ITR SET NOTE:
 THESE ITR SET DRAWINGS HAVE BEEN MARKED UP WITH KNOWN MARKUPS/REVISIONS IN PROCESS AS NOT TO BE RE-COMMENTED ON VIA THE ITR PROCESS & ADVISE ITR REVIEWER OF KNOWN FORTCOMING CHANGES. THESE MARKUPS HAVE BEEN DONE / IDENTIFIED WITH YELLOW BACKGROUND TEXT BOXES. PLEASE USE ALTERNATE COLOR FOR ITR COMMENTS WHICH I WILL REVIEW / TAKE INTO CONSIDERATION BEFORE CADD/DESIGN IS TO EXECUTE.

| DEPARTMENT OF THE NAVY NAVAL FACILITIES ENGINEERING COMMAND ~ MID-ATLANTIC JACKSONVILLE, NC MCB CAMP LEJEUNE JACKSONVILLE, NC P1338 II MEF SIMULATION/TRAINING CENTER REPLACEMENT MECHANICAL - SITE PLAN | | |

PRE-FINAL ITR SET 2021-05-28

ENLARGED HVAC MECHANICAL ROOM PIPING

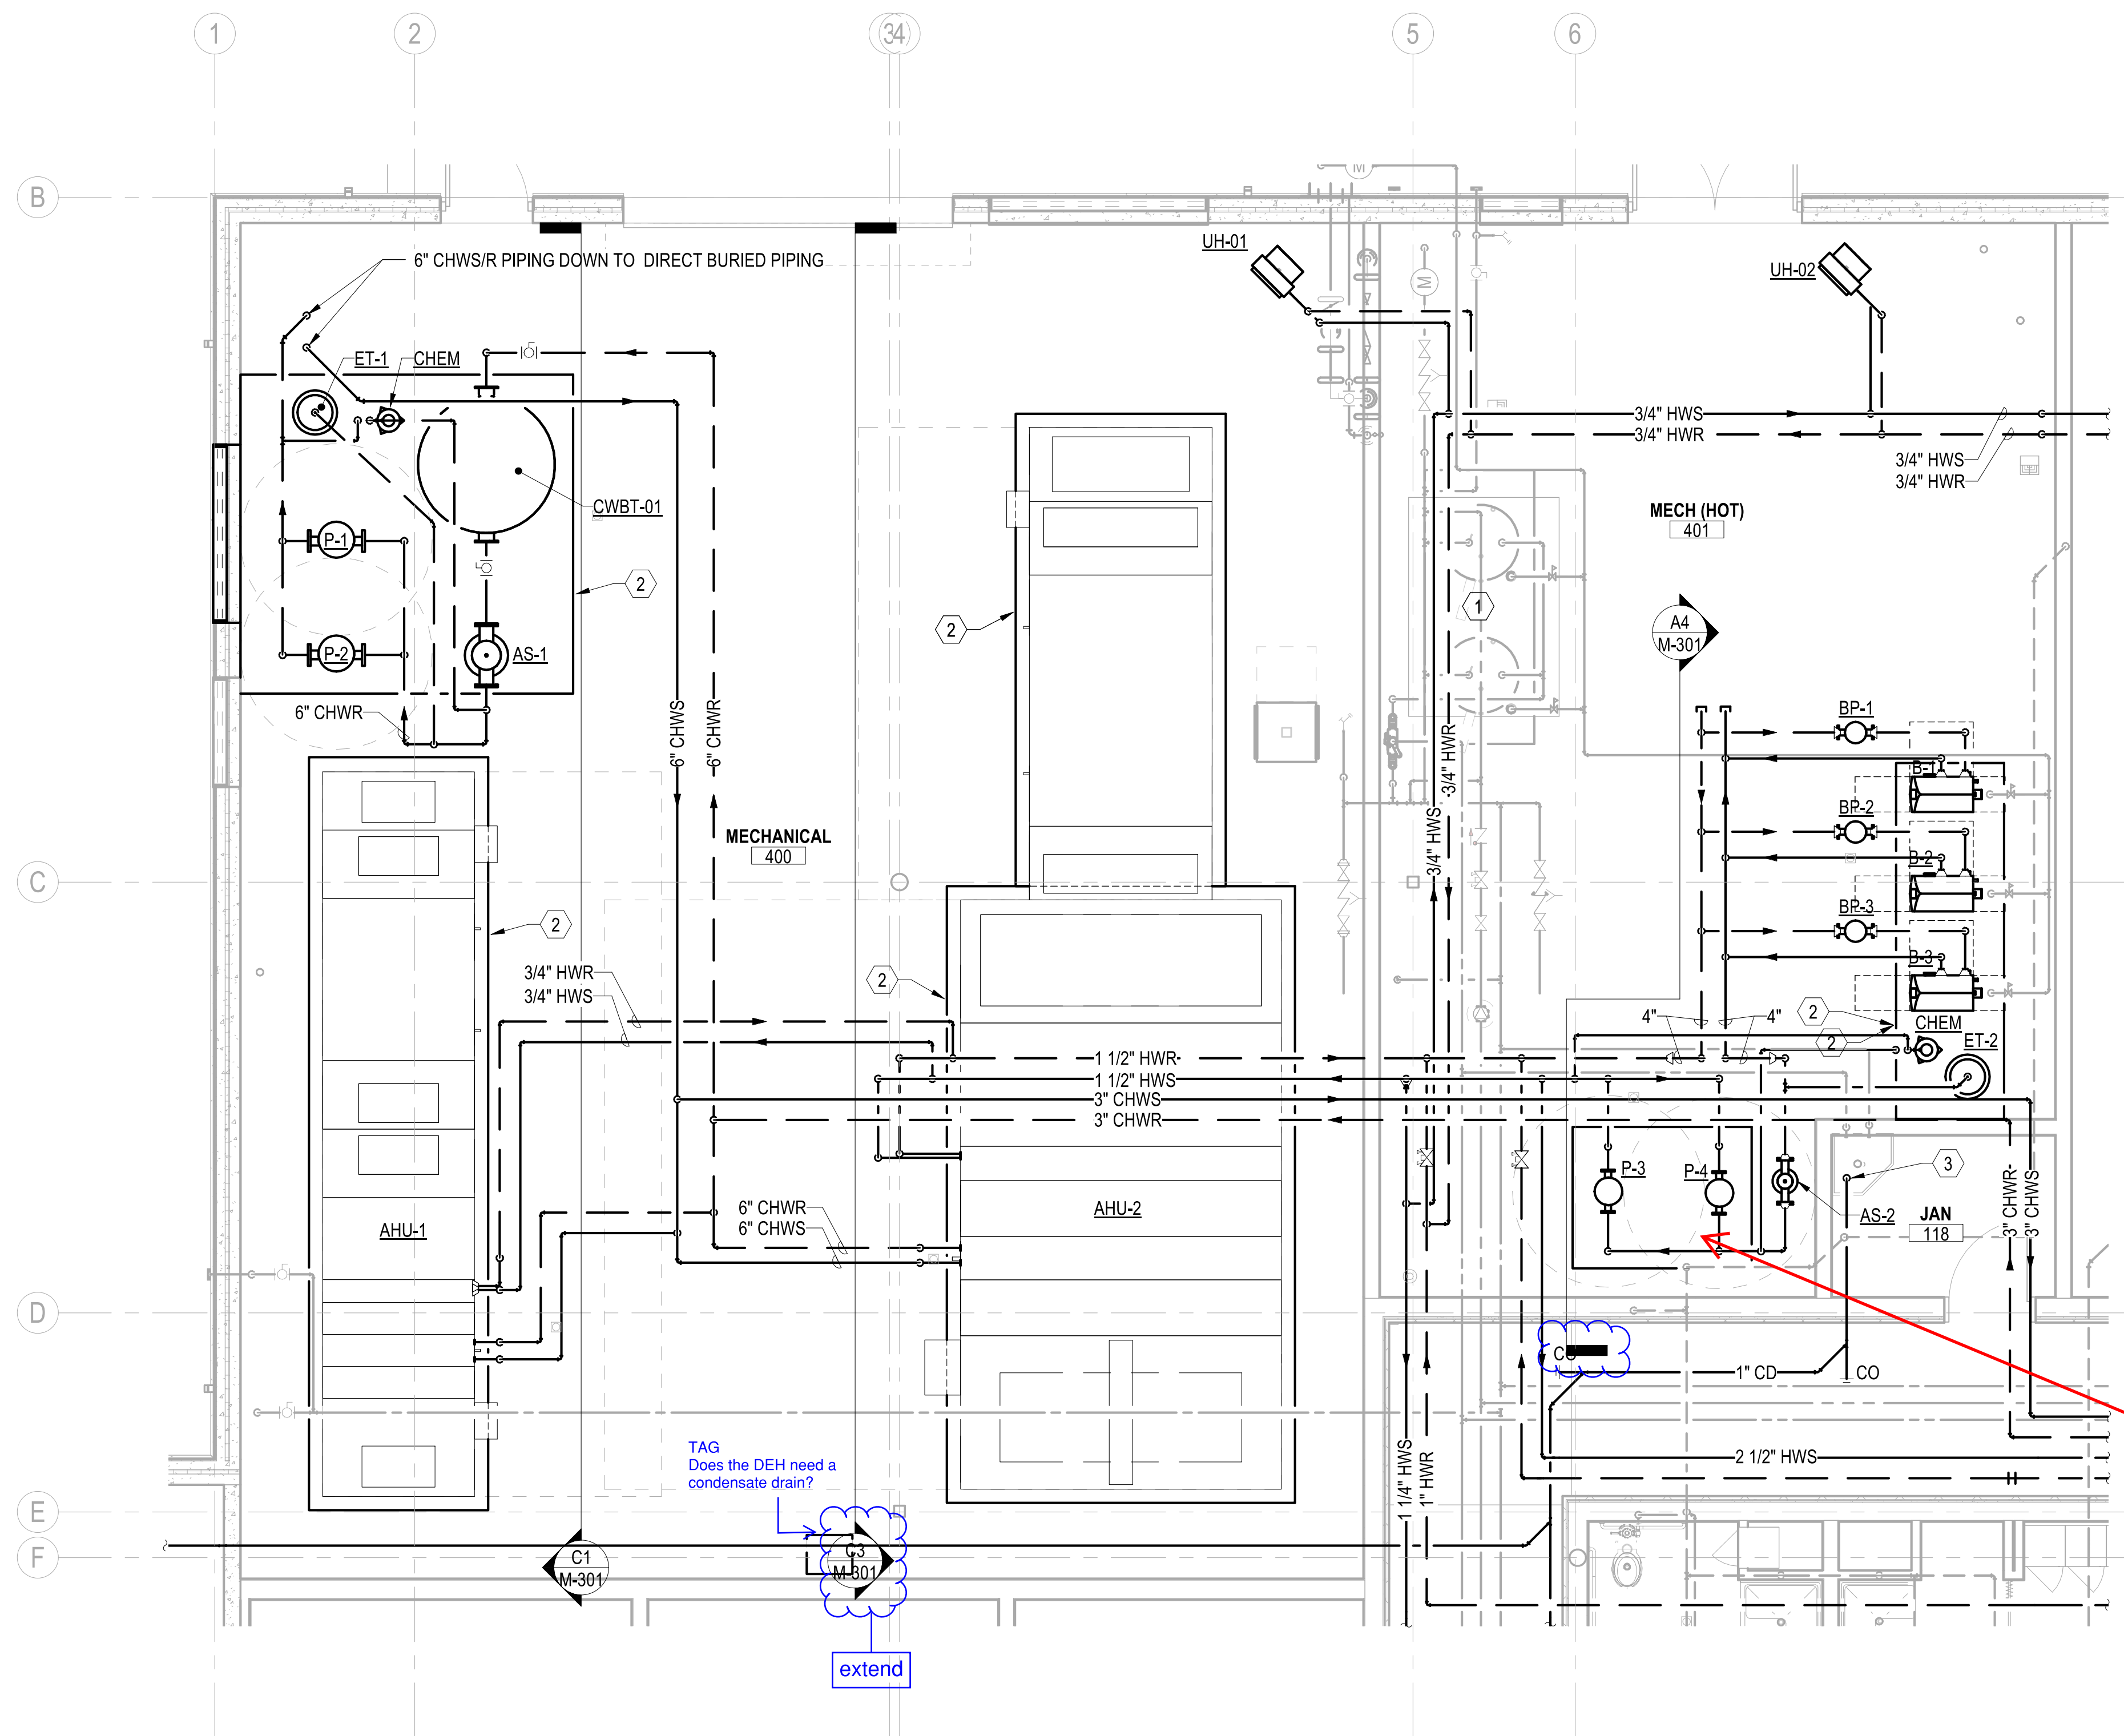
PUT THESE ON THE WALL, ON A RACK, REFER TO DETAIL C-1 M-507

ENLARGED SIM CONTROL (SERVER ROOM) ROOM 304A FLOOR PLAN
SCALE: 1/4" = 1'-0"
MH110 A1

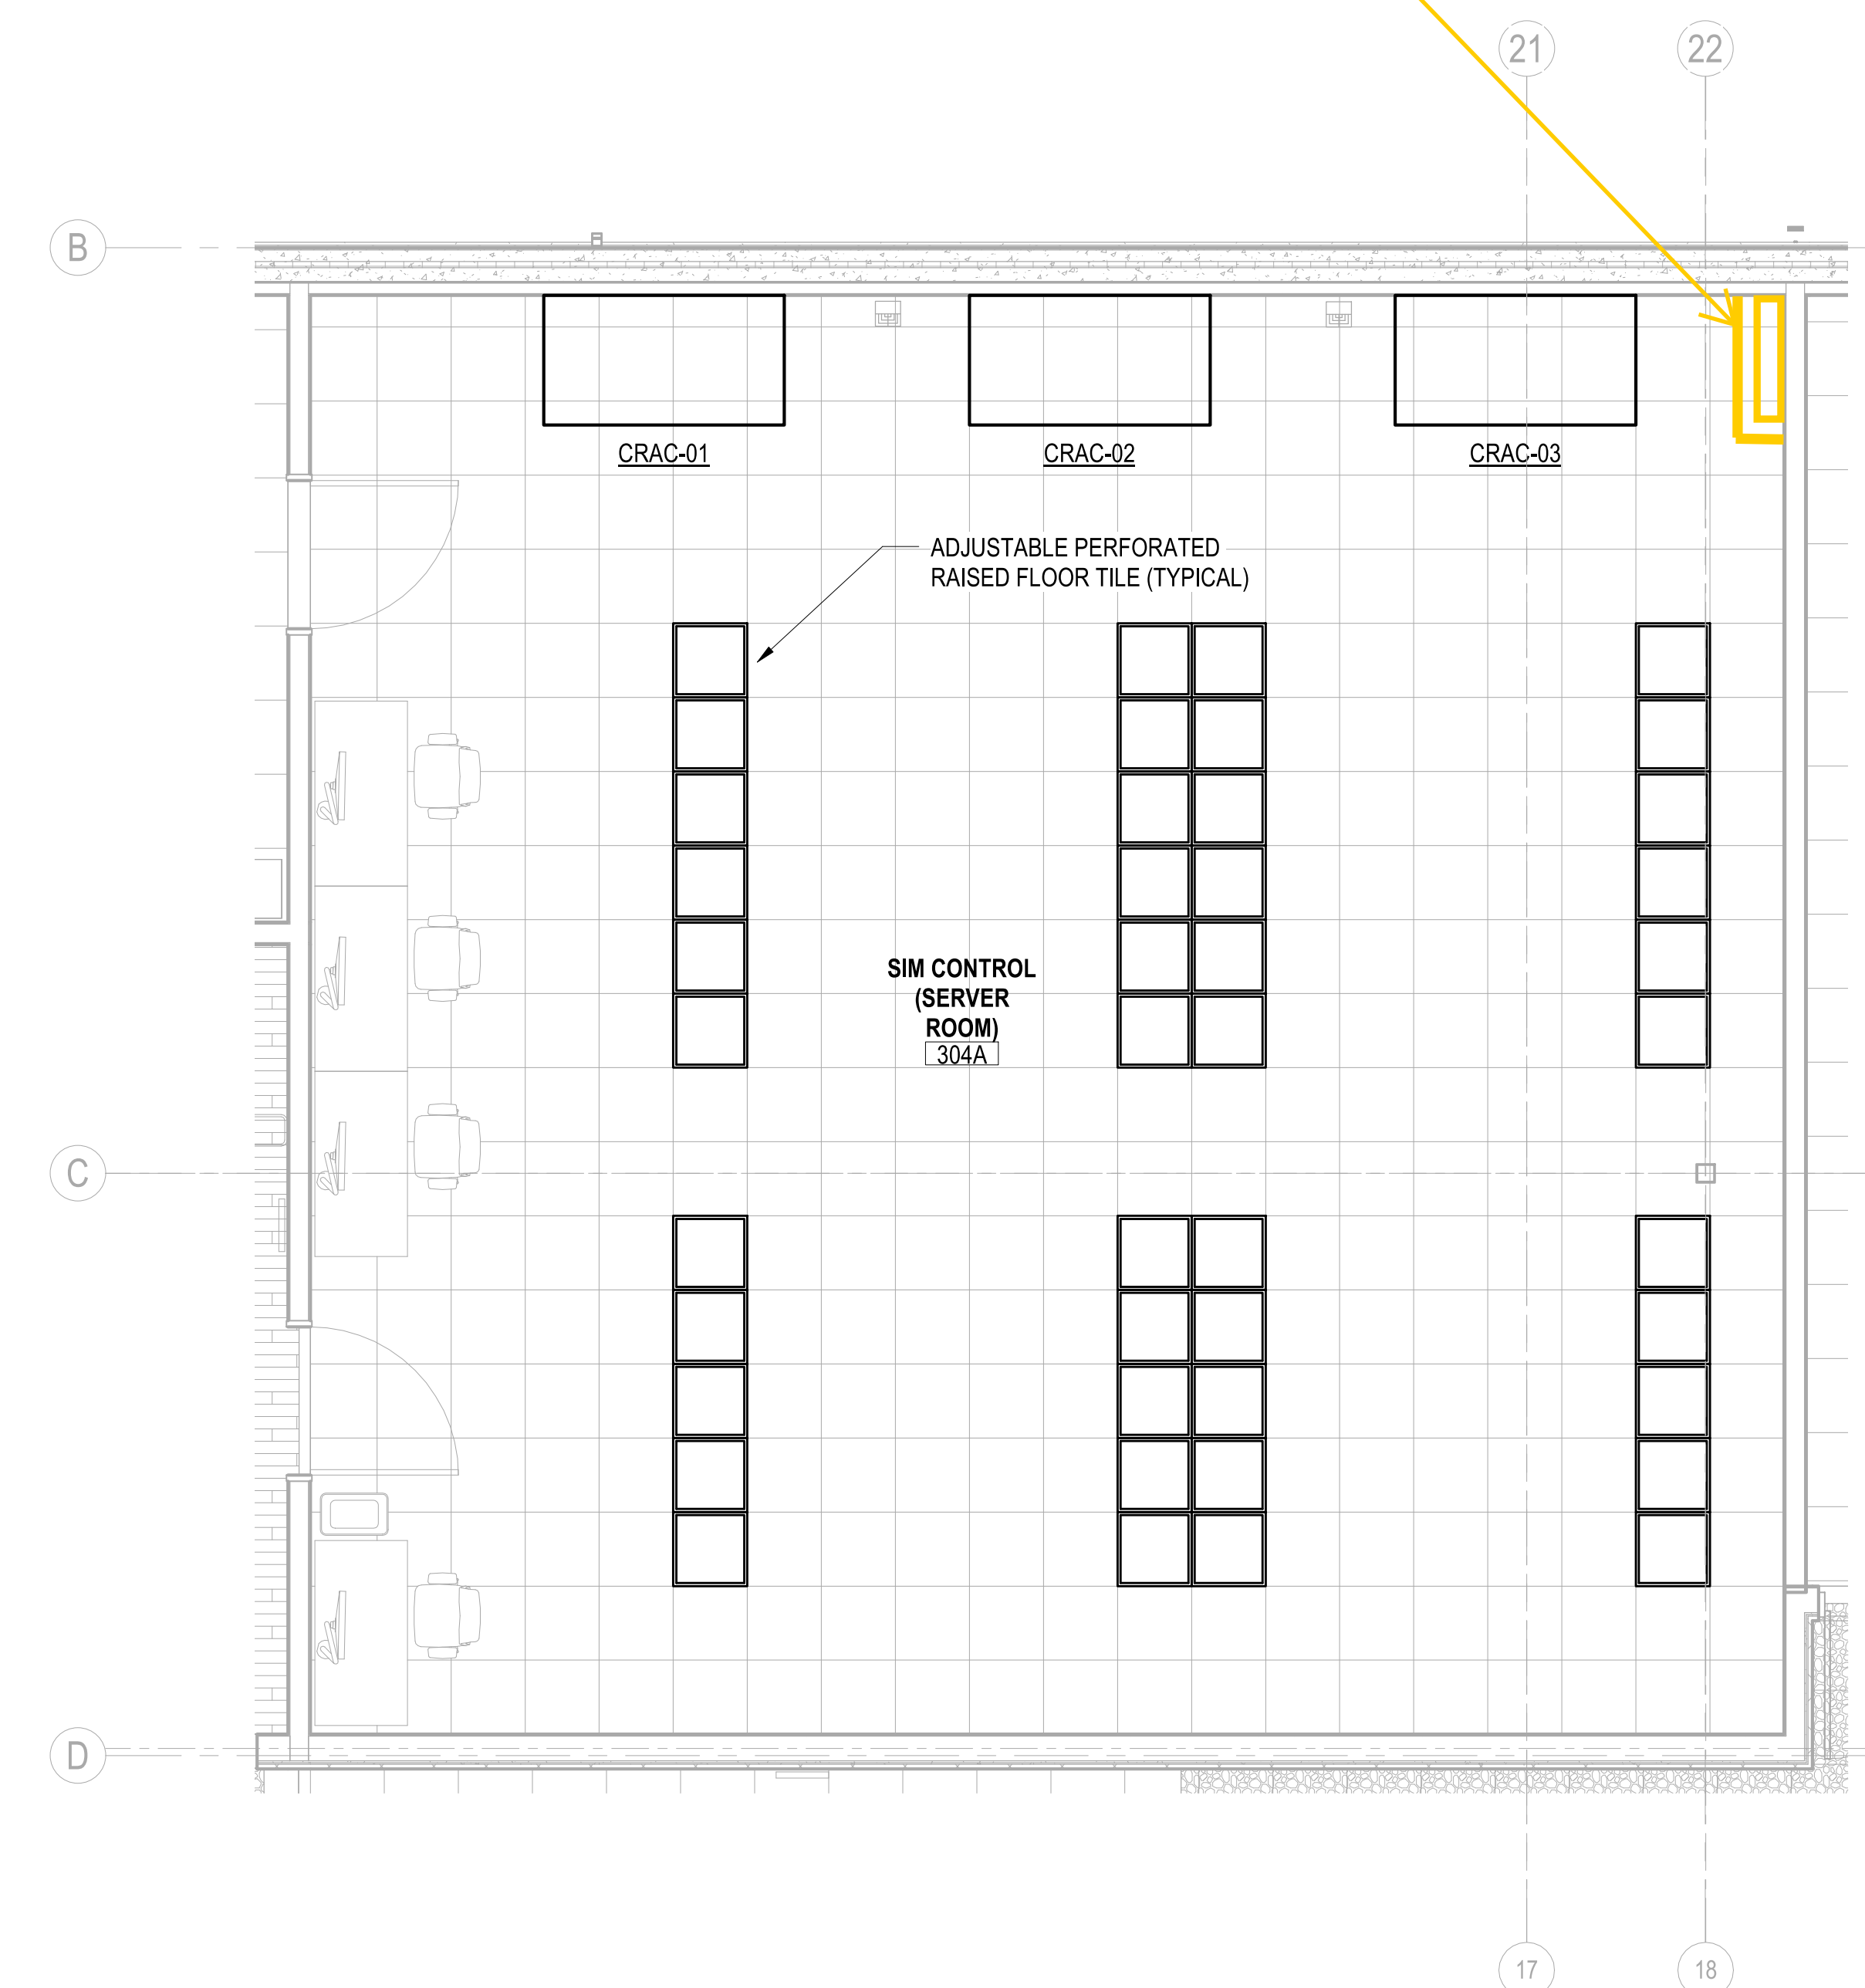
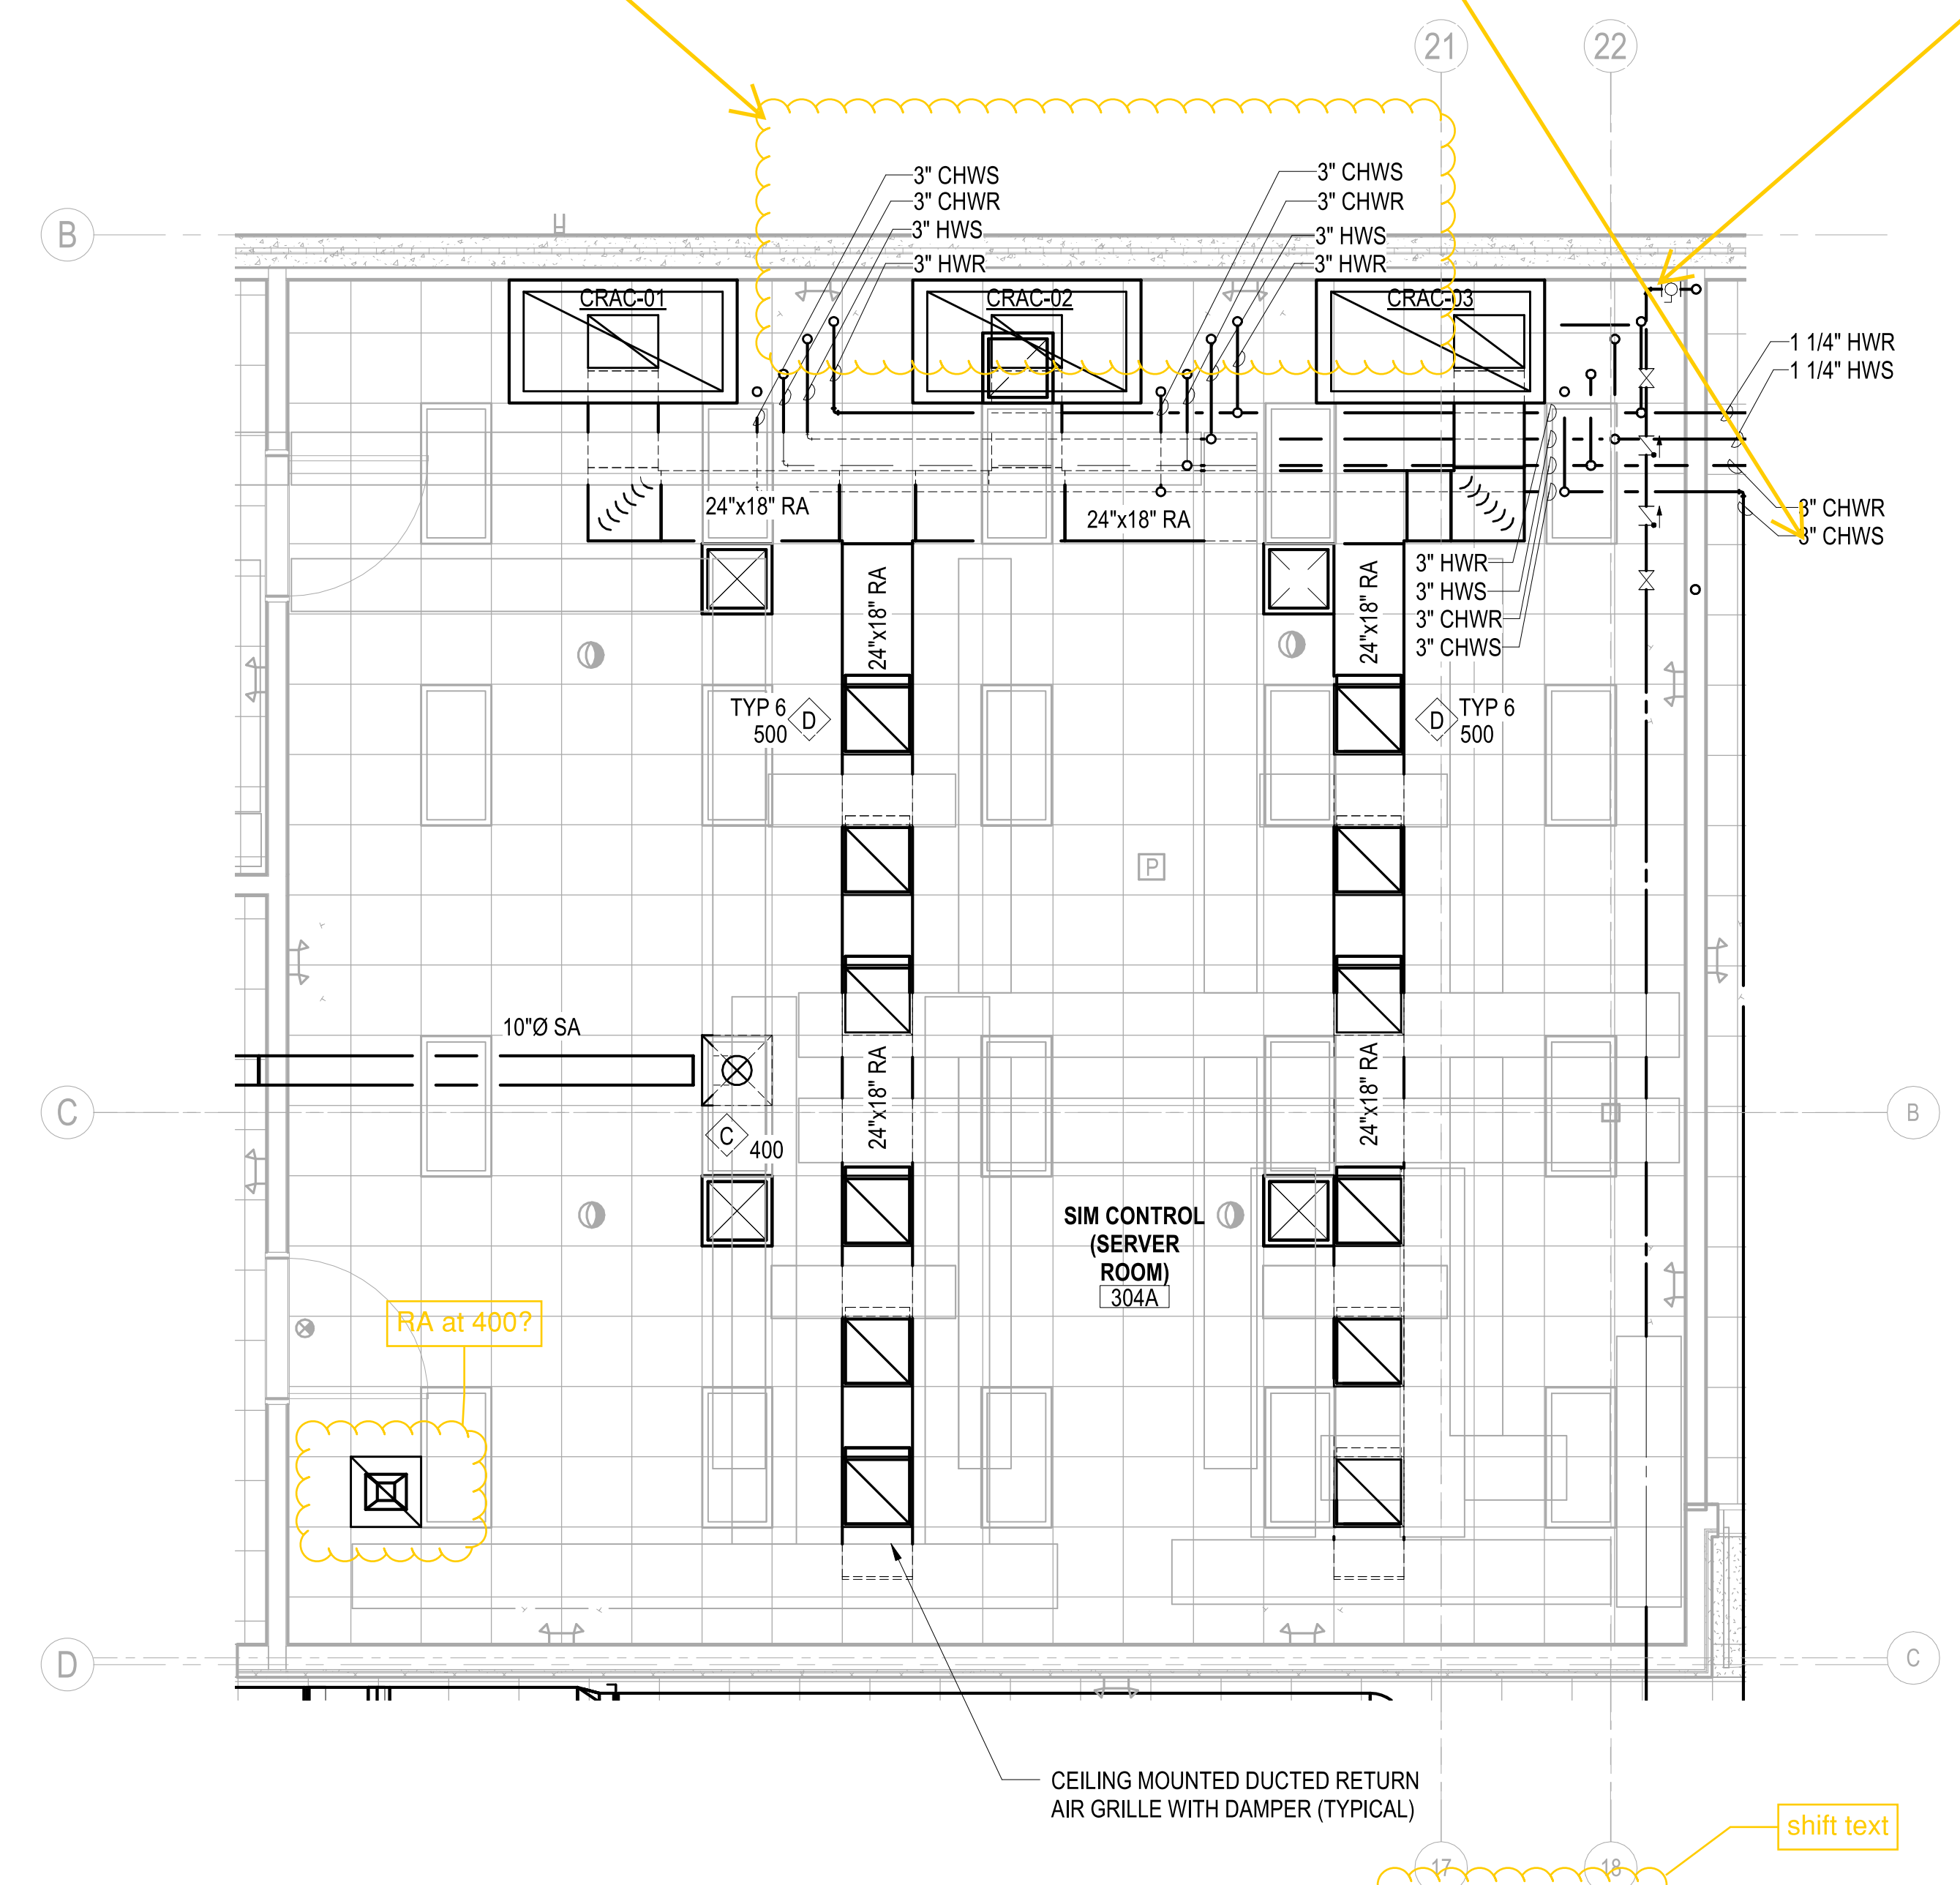
SHOW PIPES DOWN WALL HERE (WILL ASK ARCH/TELECOM OF A CHASE CAN BE PROVIDED OR IF EXPOSURE IN ROOM IS ACCEPTABLE). PIPING FOR CRACKS IS BELOW GRADE.

PERHAPS DON'T SHOW PIPE SIZES, JUST NOTE "REFER TO CHILLED WATER FLOW DIAGRAM ON SHEET M-702 FOR PIPING SIZES AND REVERSE RETURN CONFIGURATION SERVING CRAC UNITS.

3" IS NOT CORRECT PIPE SIZE; ONLY 2 UNITS ARE TO RECEIVE FLOW AT ANY GIVEN TIME - TOTAL FLOW-62.6 GPM=2.5" PIPE=

KEYNOTE THIS "DOMESTIC WATER FOR CRAC HUMIDIFICATION - REFER TO PLUMBING DRAWINGS (IS THIS COMING FROM ABOVE OR BELOW, HOW DOES IT DROP DOWN?)
